Product Change Notice (PCN)

PCN Number: PCN-0381414R-01

CMS-15116-SP

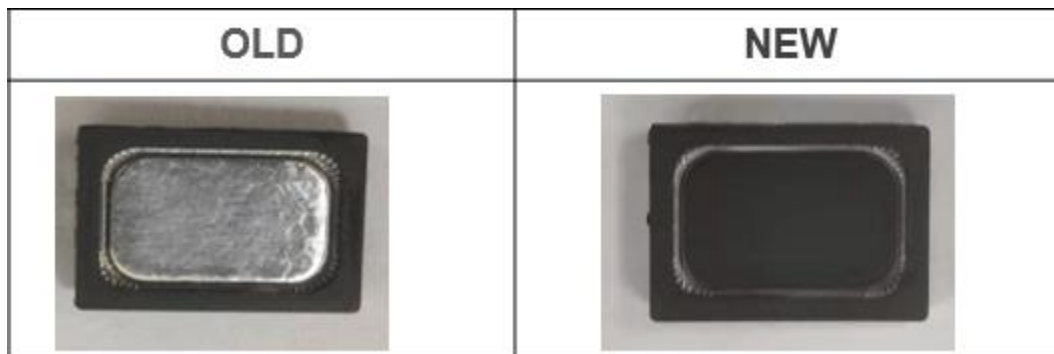
In order to prevent the silver foil diaphragm from scratching we are adding a black epoxy on the surface. This does not change any of the speakers performance

- Black epoxy on surface to prevent scratching
-
